SPD1000X Over Current Protection (OCP) function added in Firmware Revision 2.1.1.9

March 15, 2022

Over Current Protection (OCP) has been added to the SIGLENT SPD1000X series of single-channel power supplies with the [SPD version 2.1.1.9](#)

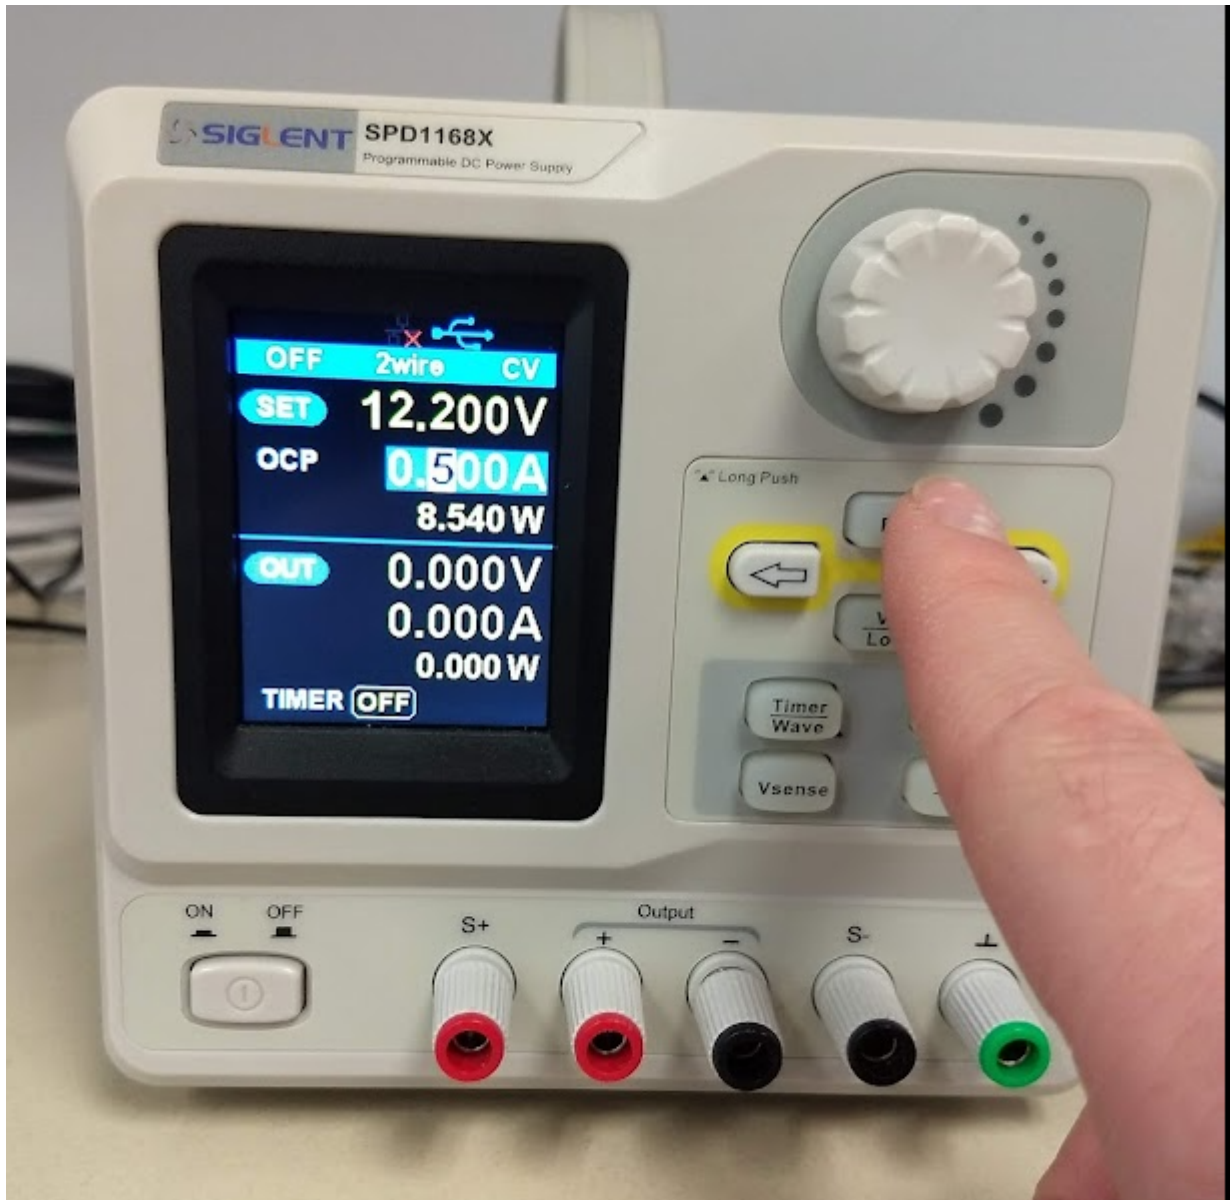
1. Update the [firmware](#)
2. Set the OCP value by pressing and holding the FINE button on the front panel. After a few seconds, the OCP label will appear:

Here is an oscilloscope trace showing a shorted output causing an overcurrent situation (OCP triggered):

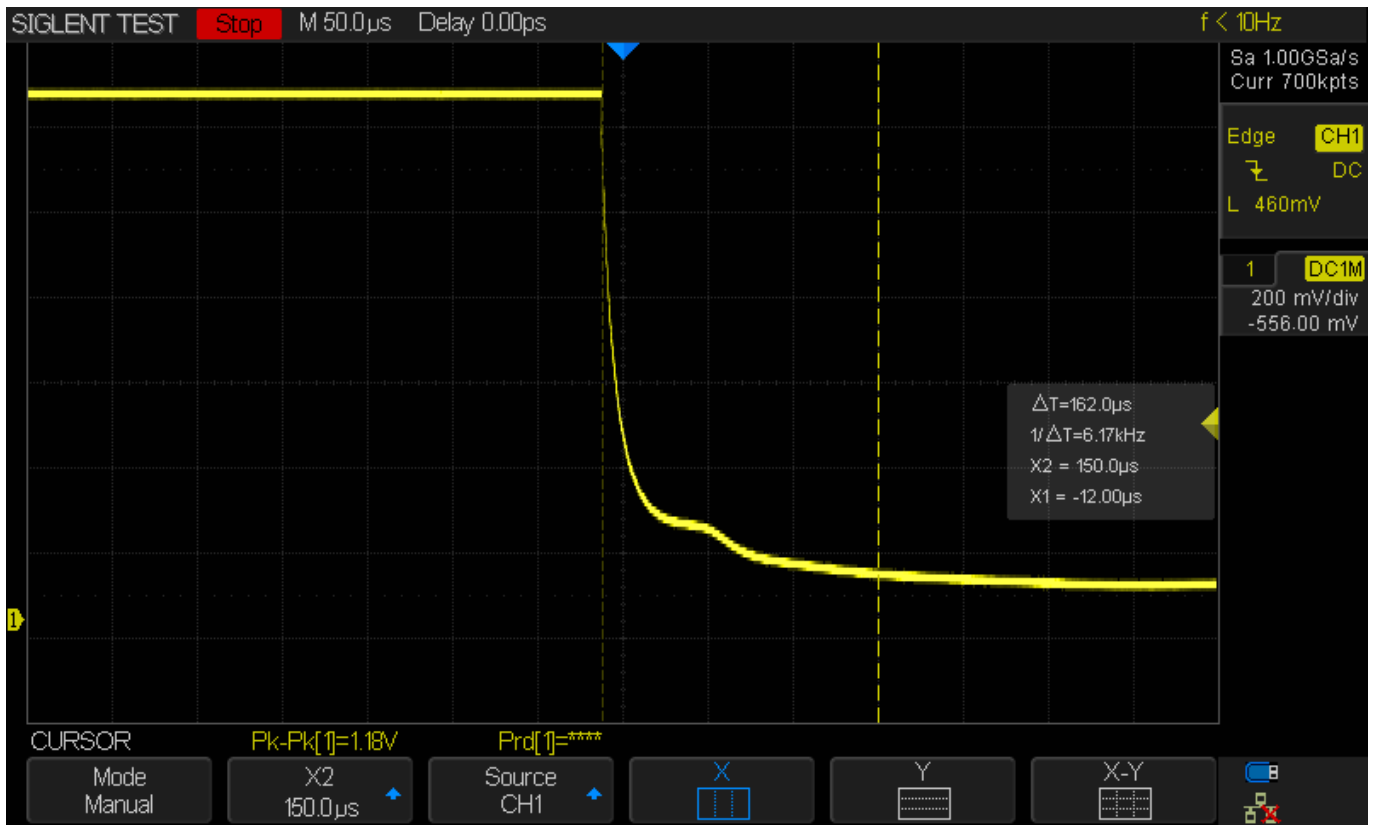
3. Set the OCP current value using the knob and right/left arrows to adjust.
4. Long press the FINE button to remove the OCP menu selection.
5. If the output exceeds the setpoint, the instrument will immediately disable the output and briefly show an error:
